ADDENDUM NO. #0

TRACK & FIELD IMPROVEMENTS

LITTLE JOB #612-12353-06

Oxnard High School

SHEET NUMBER
C2.0

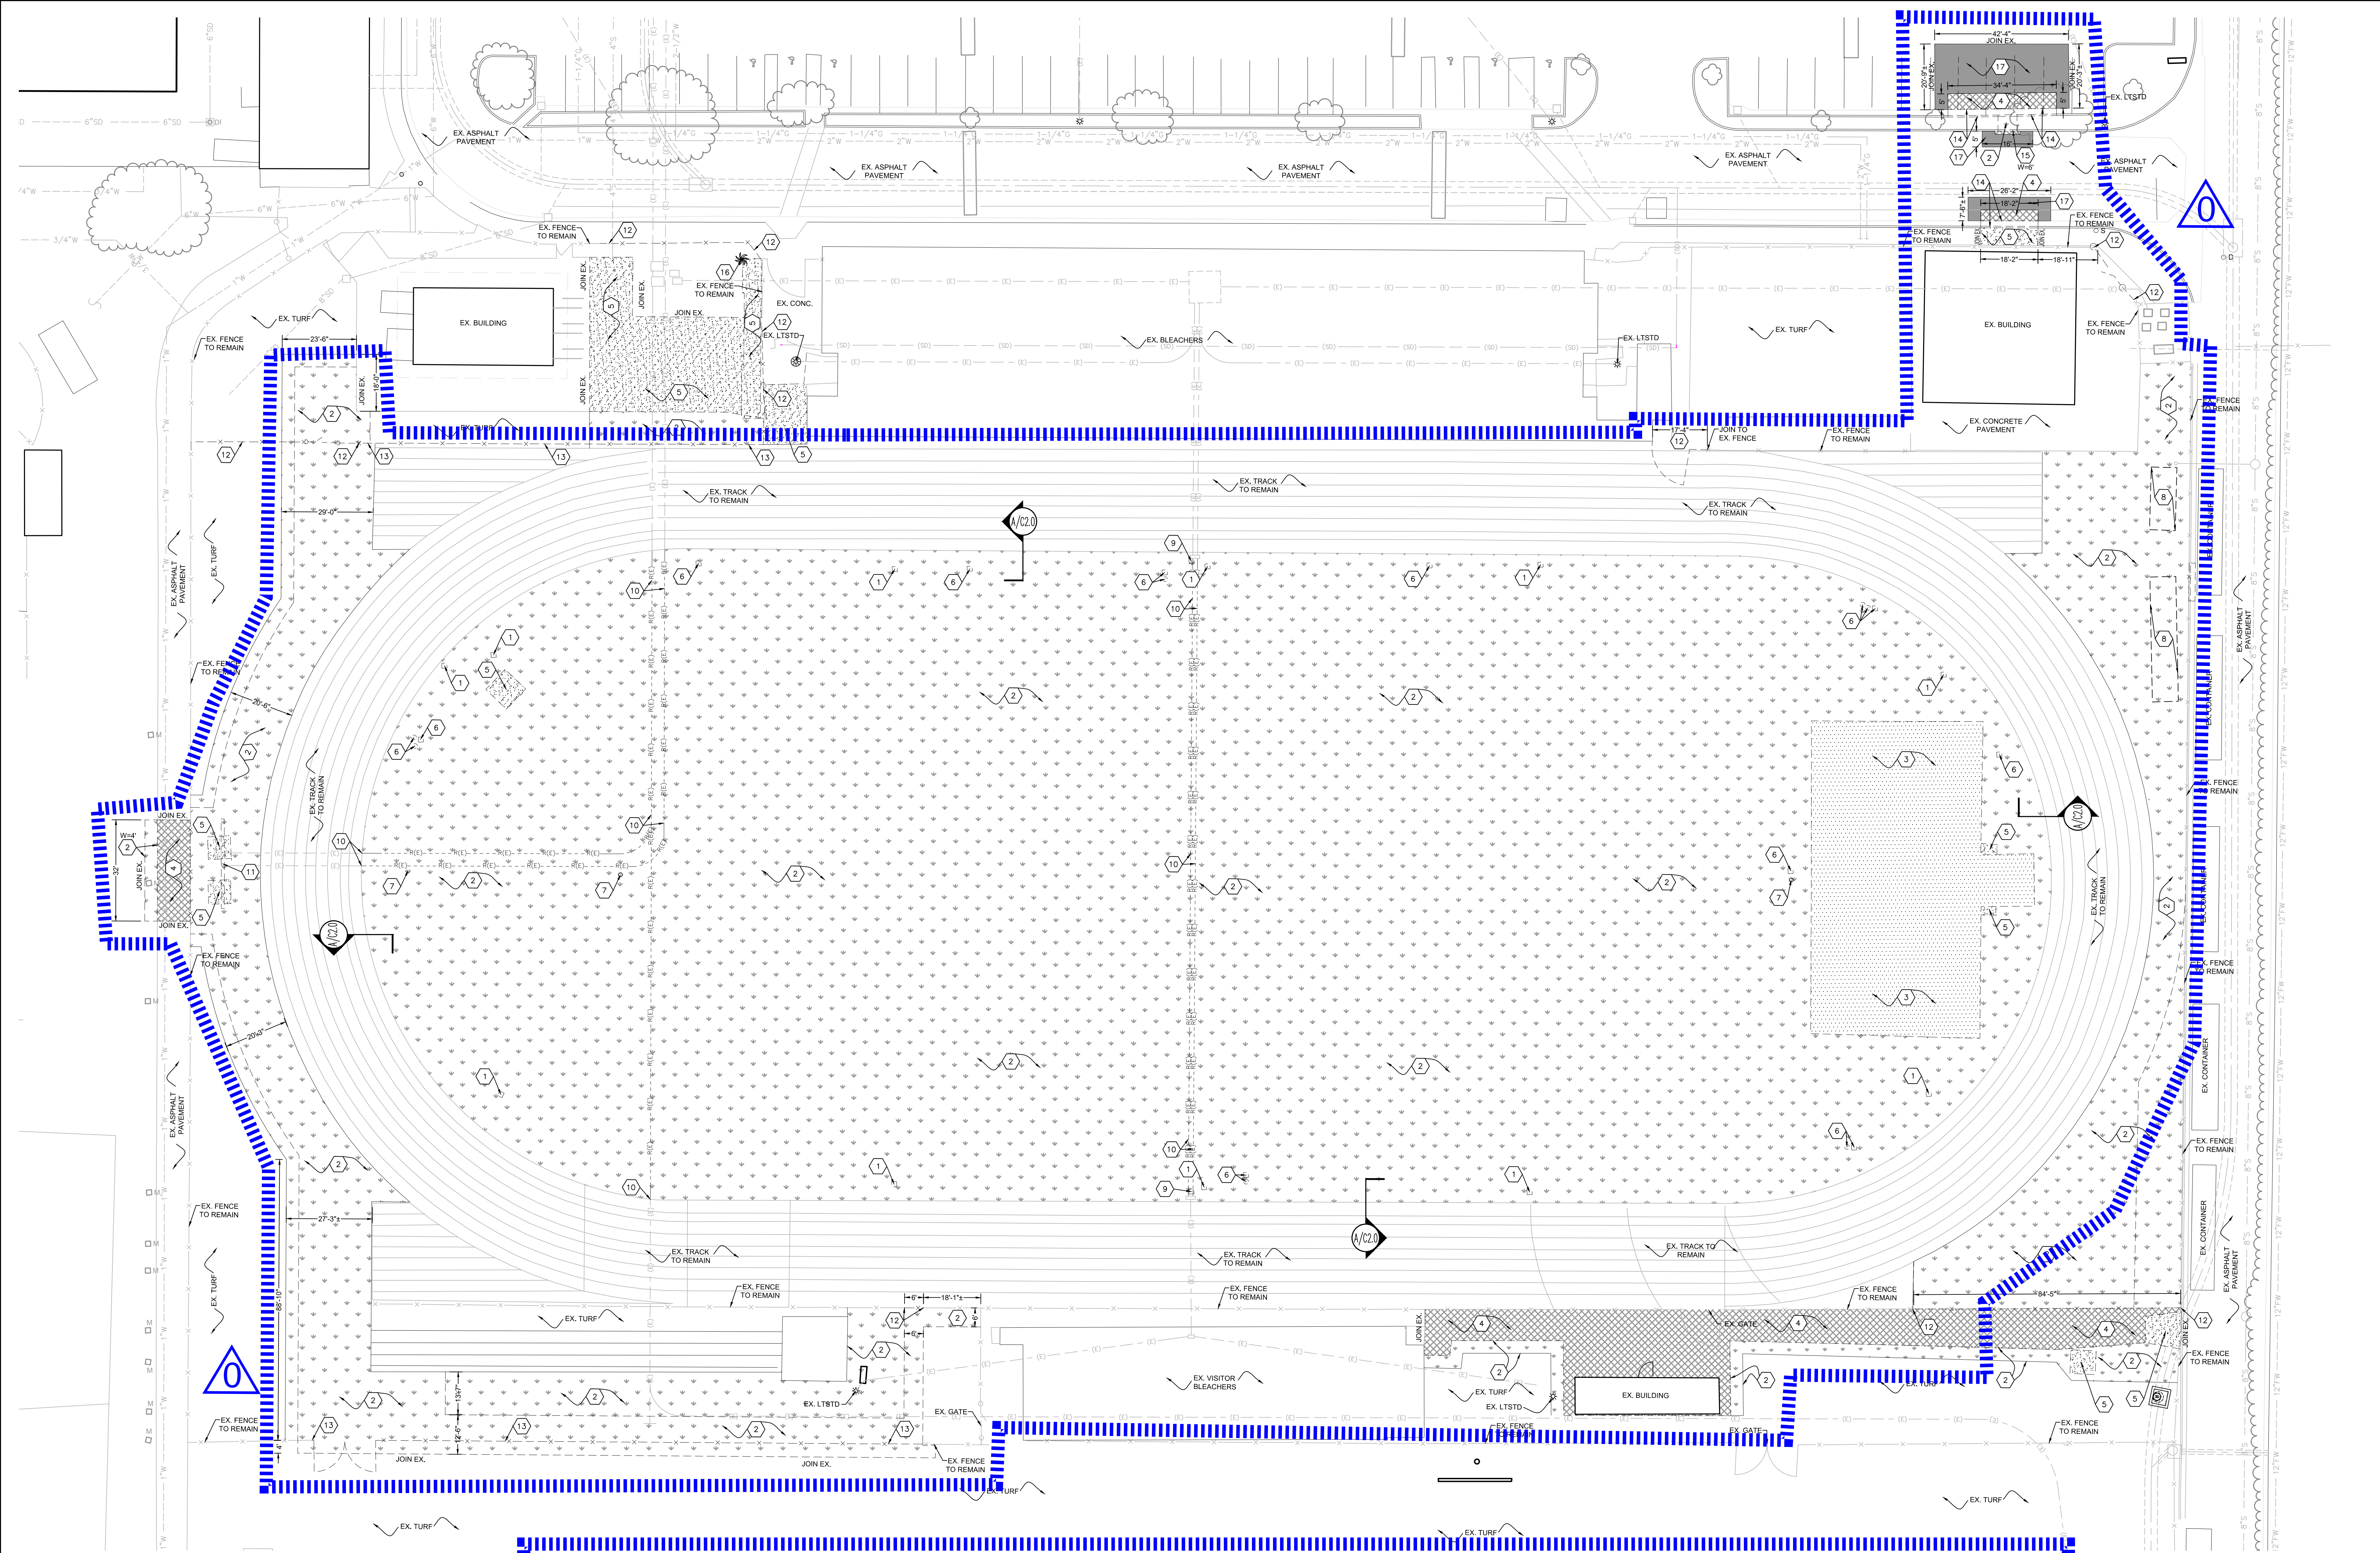
- 3.1.2.1.** Drawing C1.0/AD0-C1 - Area of work has been revised as shown on this sheet.
- 3.1.2.2.** Drawing C2.0/AD0-C2 - Only work within outlined area is included in scope of this project and bid. Any work shown outside of the delineated area is not part of this project.

C3.0 AD0-C3

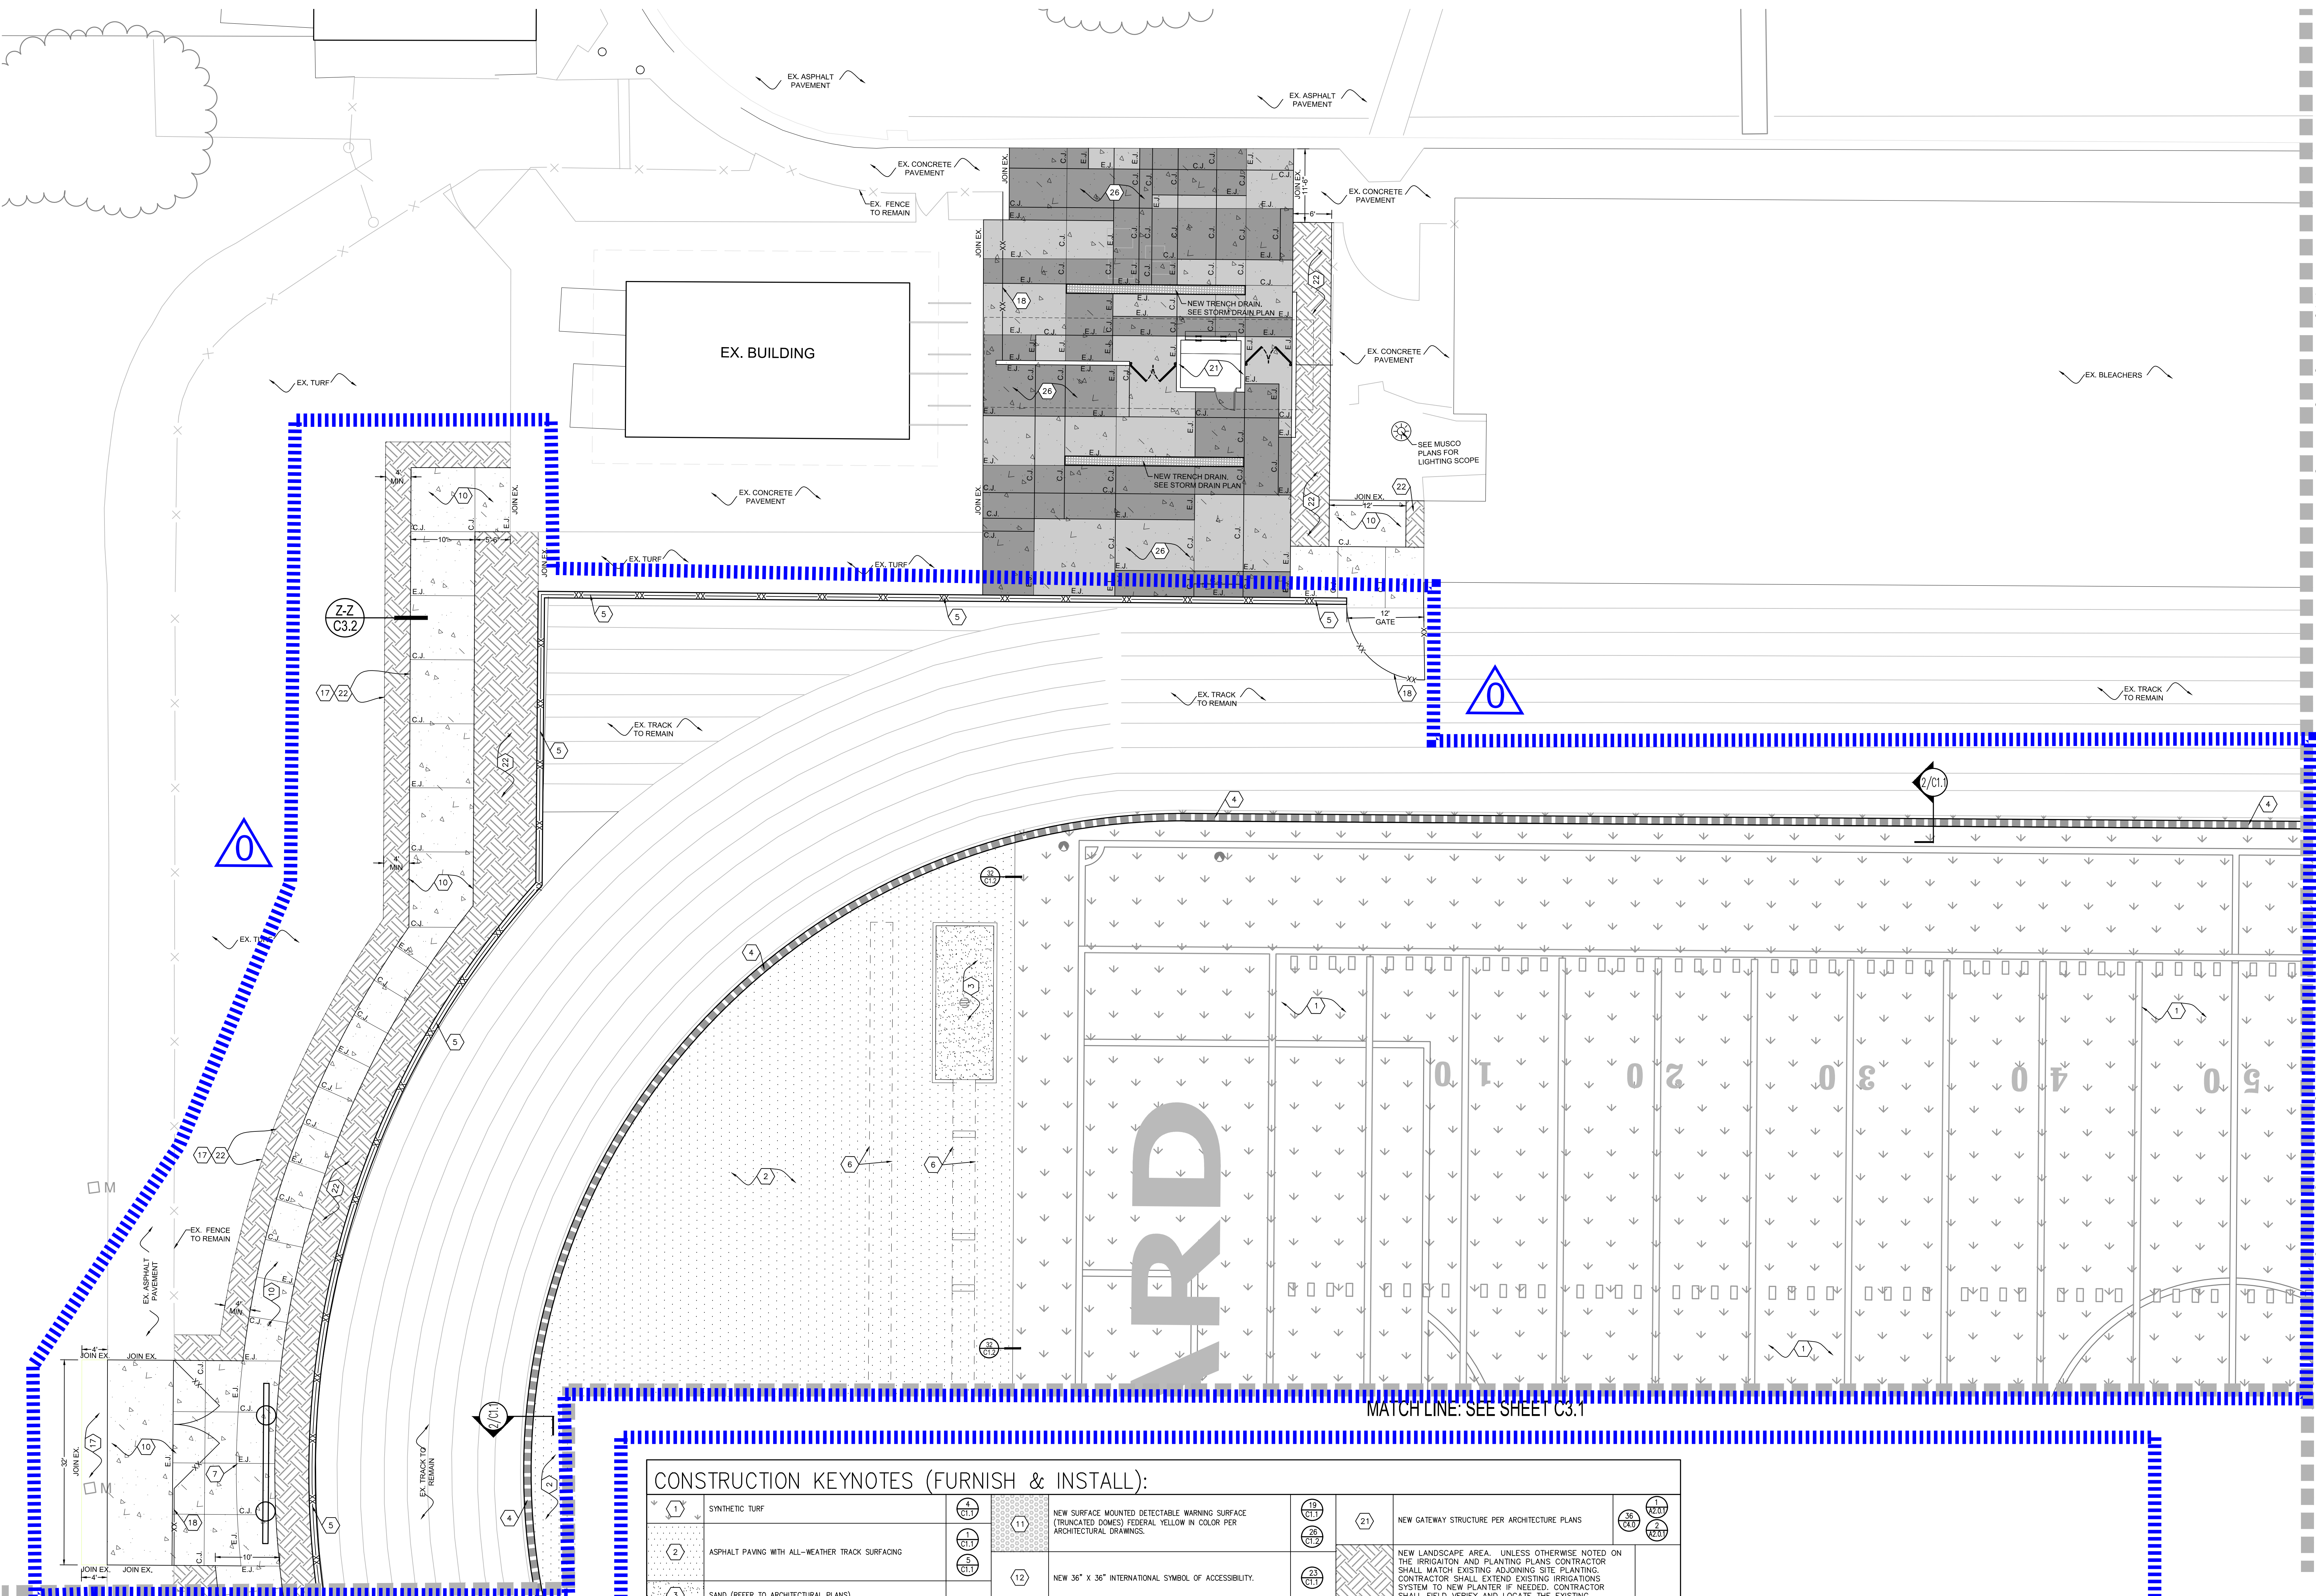
- 3.1.2.3.** Drawing C3.0/AD0-C3 - Only work within outlined area is included in scope of this project and bid. Any work shown outside of the delineated area is not part of this project.
